Mark & Hold

Miklos Lukacs, April 2017

Adding a technical feature now !?

What is Mark & Hold

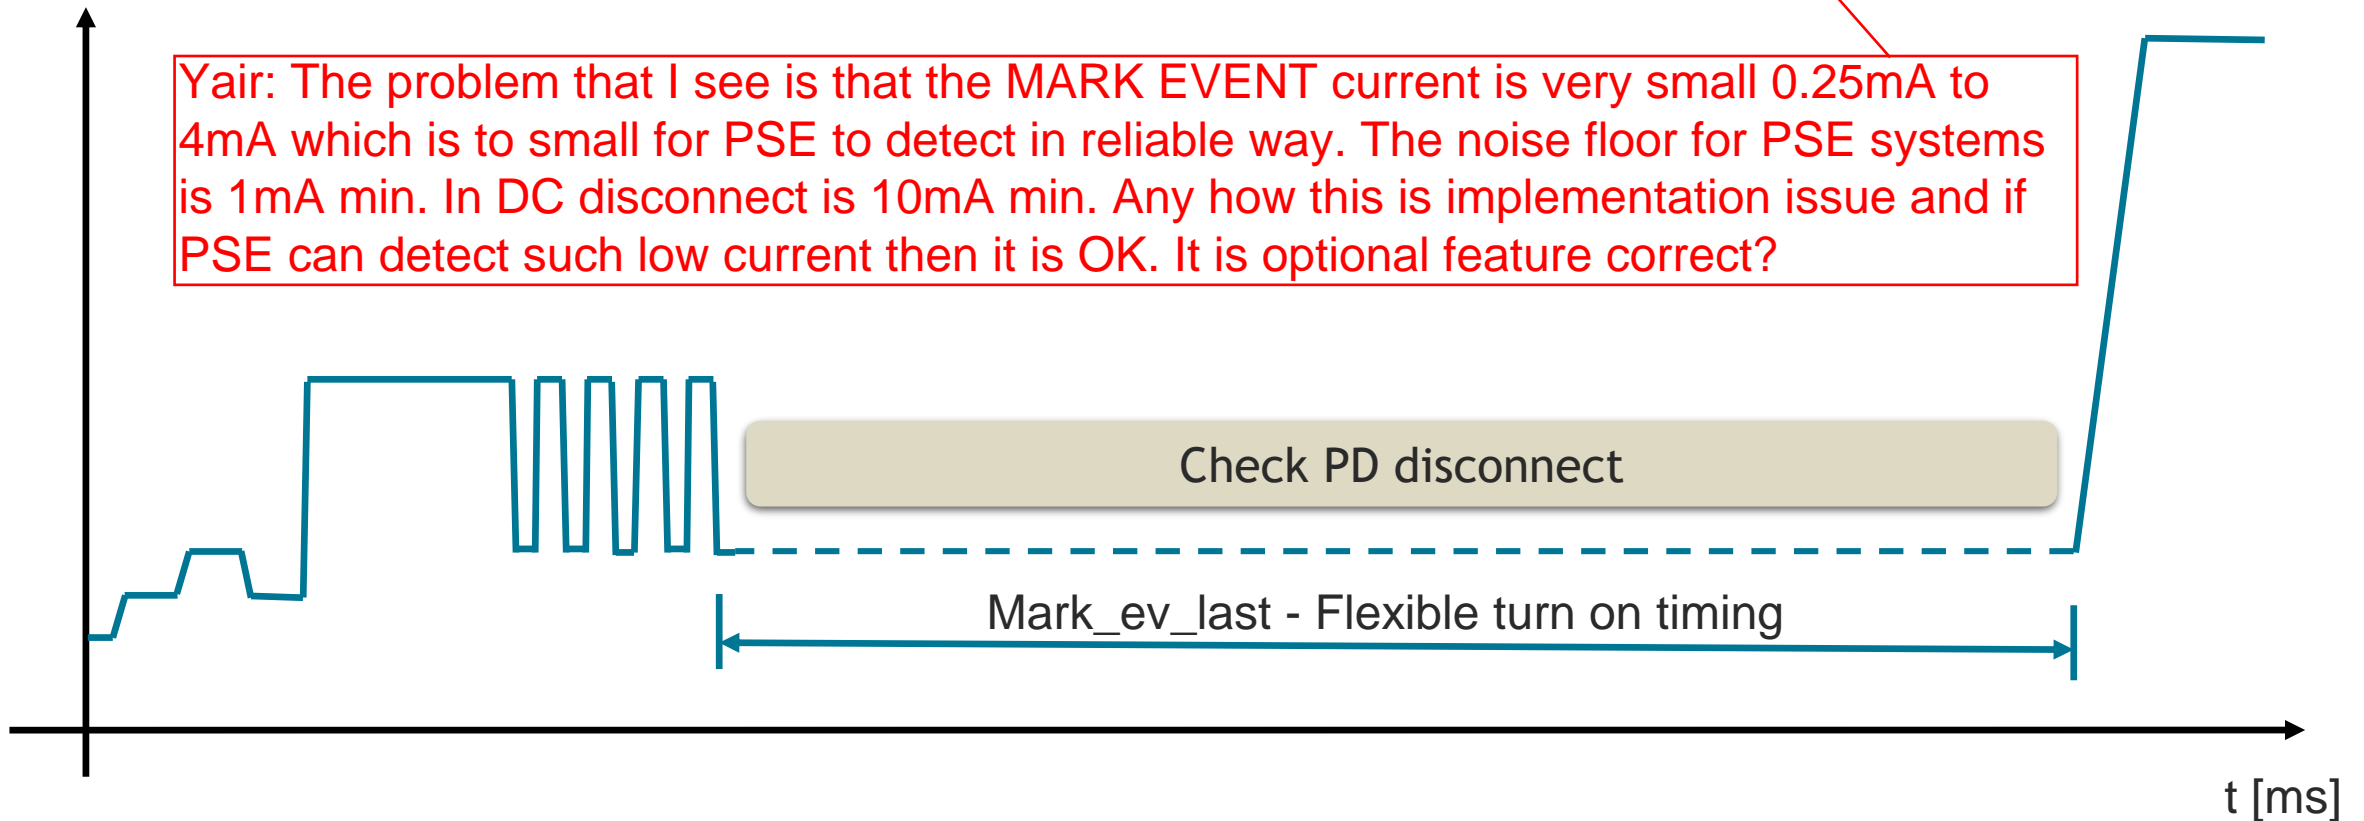
Yair: The problem that I see is that the MARK EVENT current is very small 0.25mA to 4mA which is too small for PSE to detect in a reliable way. The noise floor for PSE systems is 1mA min. In DC disconnect is 10mA min. Anyhow this is an implementation issue and if PSE can detect such low current then it is OK. It is an optional feature, correct?
